Photograph of a Syphon well drop in the Palayamparavoo channel ——
Furnishing the Government of India with eight unmounted copies of ——

Photo of Syphon well drop in the new Palayamperavo Channel - Forwards a — with a request to be informed if any more Copies & the negative are required.

Syphon well drop in the new Palayamperavoo channel. Forwarding report in connection with the ——.

M. No: 306 A
1910
5 FT WELL DROP
AT 8976' OF
NEW PALIAMPARAVOO CHANNEL
SCALE 1/100
PLAN
C.R. No: 351/1213
TOP OF BANK
BERM
DRAIN
ON A.A
CROSS SECTION OF TUNNEL
ON C.C.
LONGITUDINAL SECTION
BED OF CHANNEL +69·55
PUDDLE CLAY
G.L +71·54
F.S.L +67·05
+64·55 BED OF CHANNEL
VIDE INSPECTION NOTE OF E.E. FOR JULY 1911
D.S. APPROVED IN S.E.'s No.
EXECUTIVE

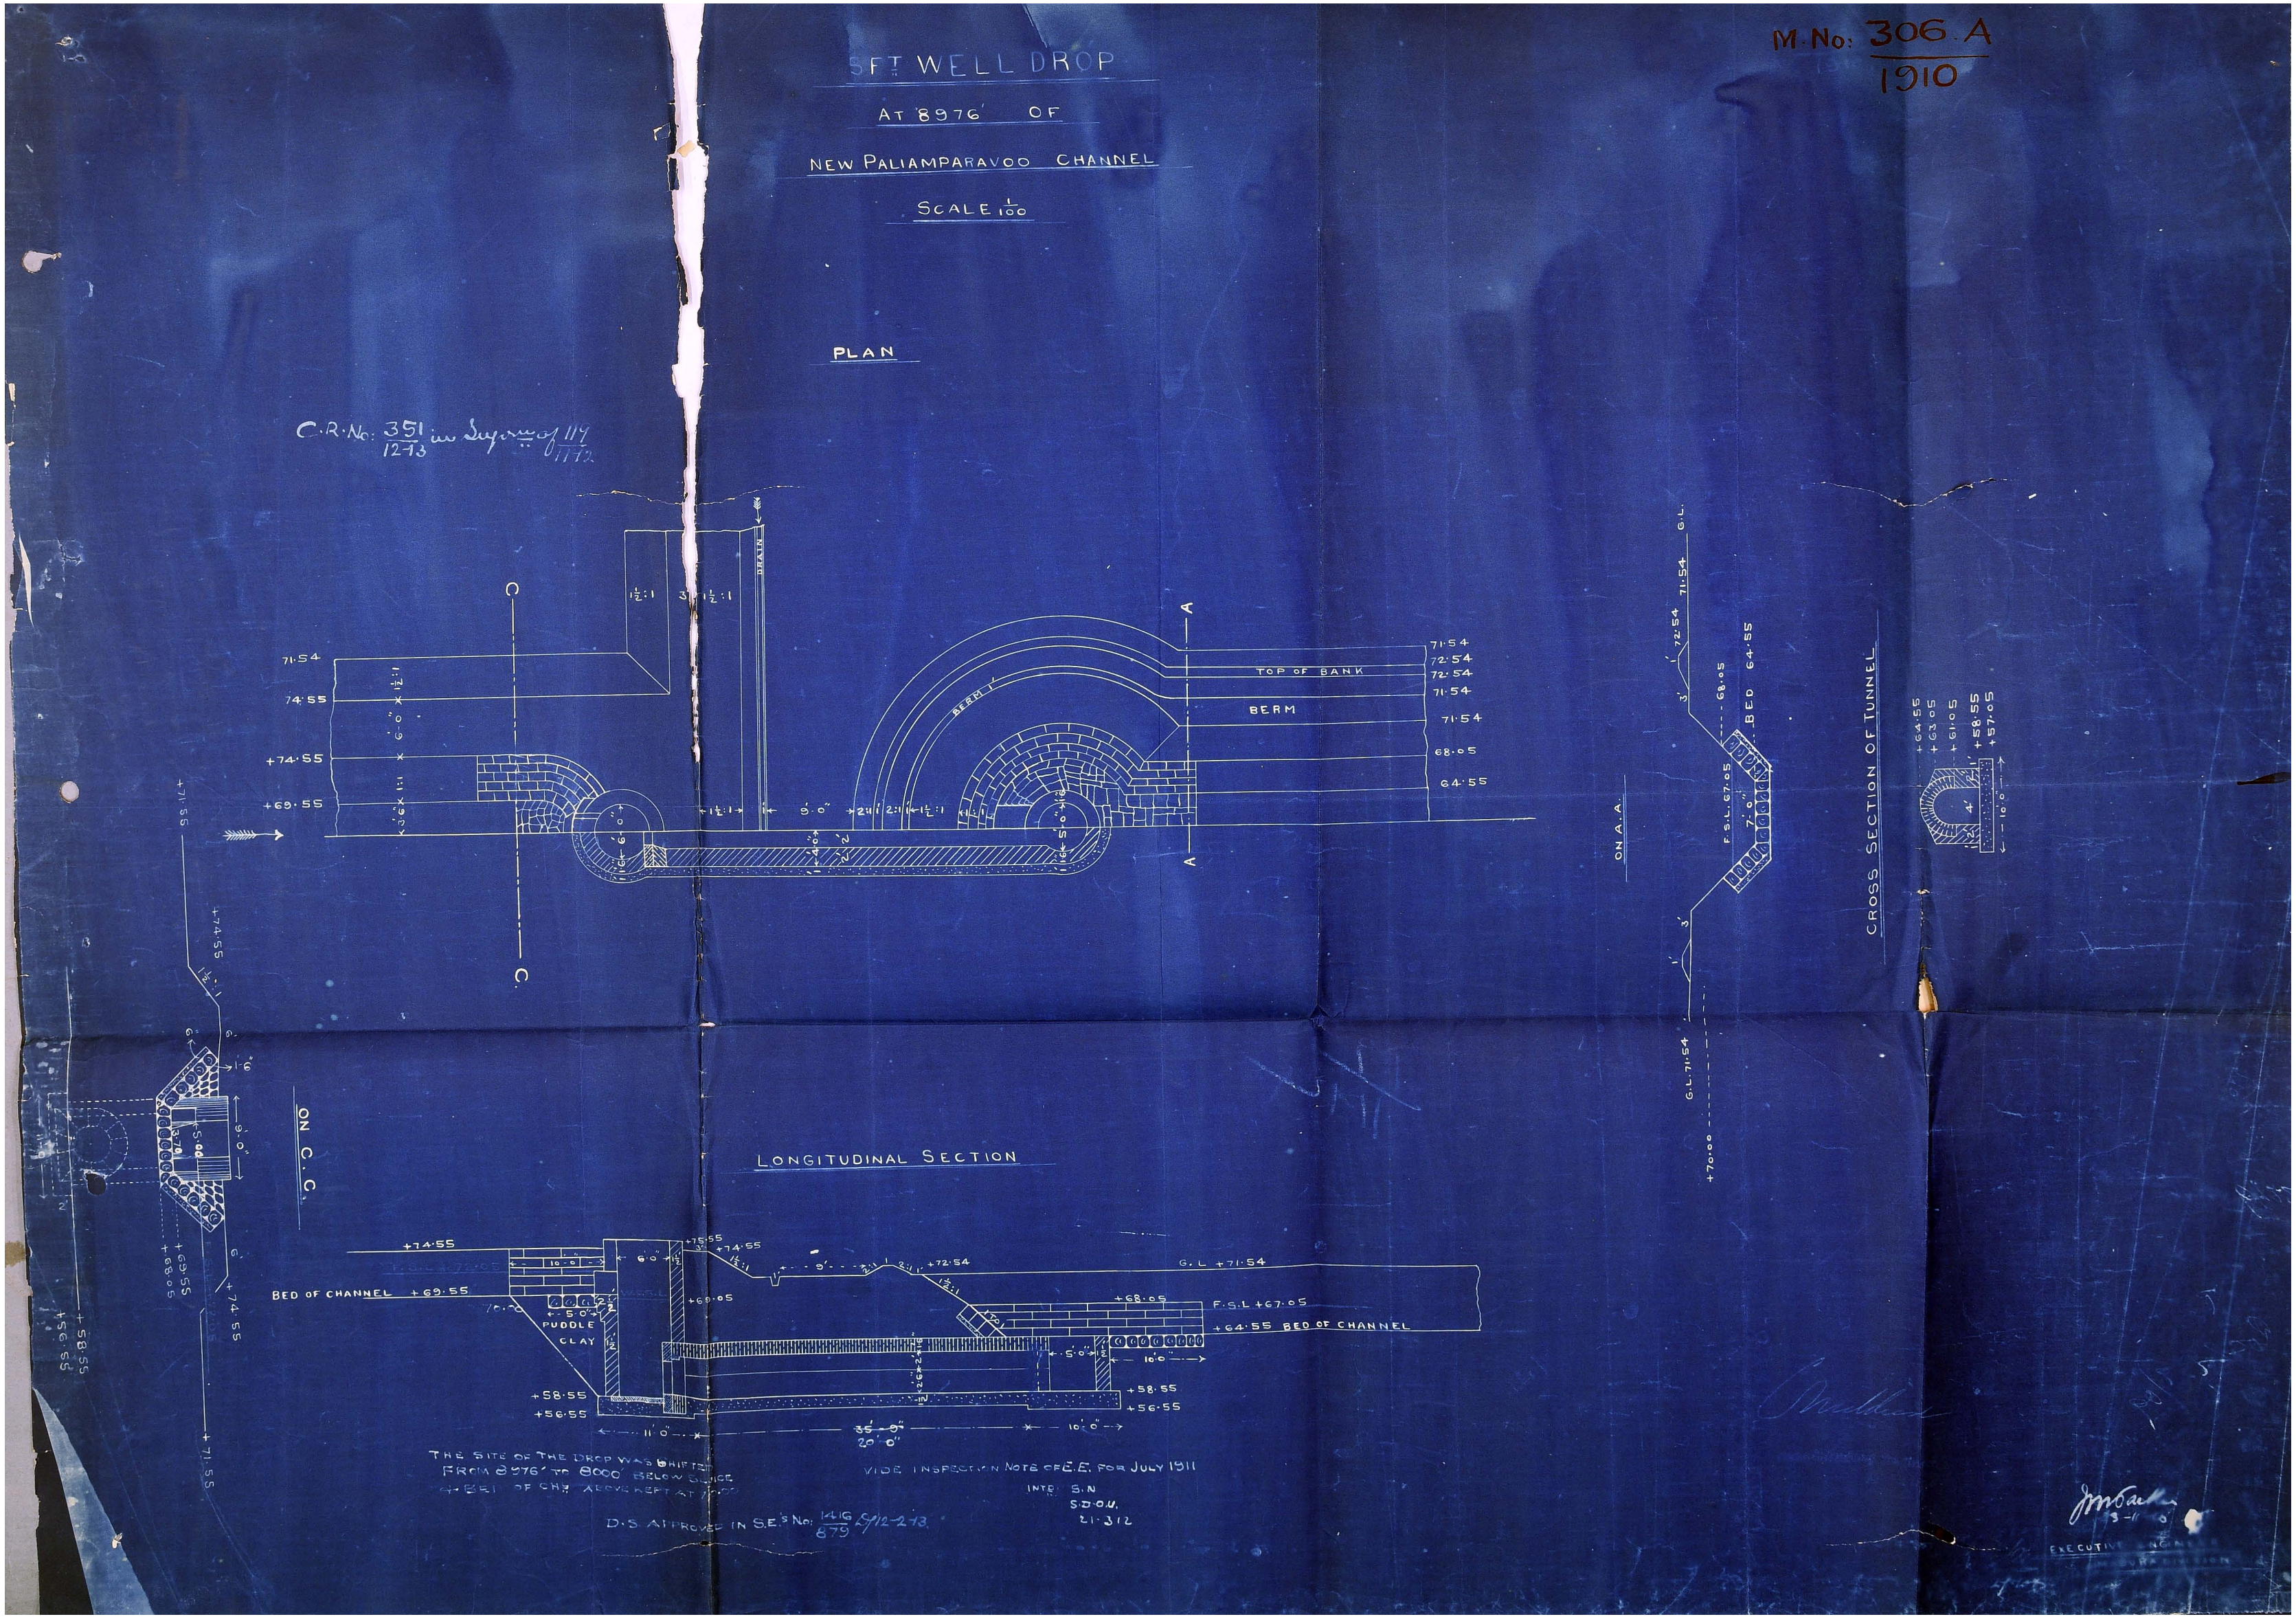
pp1-2 CS – With ref. to letter N. 341 CE d/4.3.14 from the 1720 S.E. VI submitting a photo of the syphon well drop on the new Palayamparavu chl: the E.I. has the honour to observe that the chl: ~~appears to be scoured~~ ~~is a bit rugged~~ but is scoured down stream but this does not appear to be due to scouring action. The S.E. is requested to state if this is attributable to the new work

2 It is not known why the entry to the well drop is not a trapezoidal notch & why it is cut back from the well instead of being merely a notch in the side of

the well steining. It [is] also not clear of the width of the earthwork behind the wall [is] sufficient for cart traffic. The S.E is req[uested] to submit a full report on these [illegible] with plan & ~~estimate~~ report ~~[illegible]~~ accompanied the estimate.
~~[illegible]~~
~~[illegible]~~
~~[illegible]~~

2. The erosion in rear of the well drop may or may not be attributable to the new work. It probably is not. The -- channel was dug in 1908 and the drop built in 1912. There is wet cultivation all round the site and water is always percolating into the channel below the drop causing slips. The revetment below the drop was not well built and was not taken high enough. If it were taken about another 1'-6" higher much of the scour would be stopped.

3. The entry to the well is a trapezoidal notch in the side of the well. On the day the photo was taken a little water was probably passing over the top of the notch; on this account probably the notch did not appear clearly in the photo.

4. The width of the earthwork behind the well is sufficient for cart traffic and carts are reported to pass that way now.

5. A blue print of the sanctioned plan is sent herewith. There is no special report on the work.
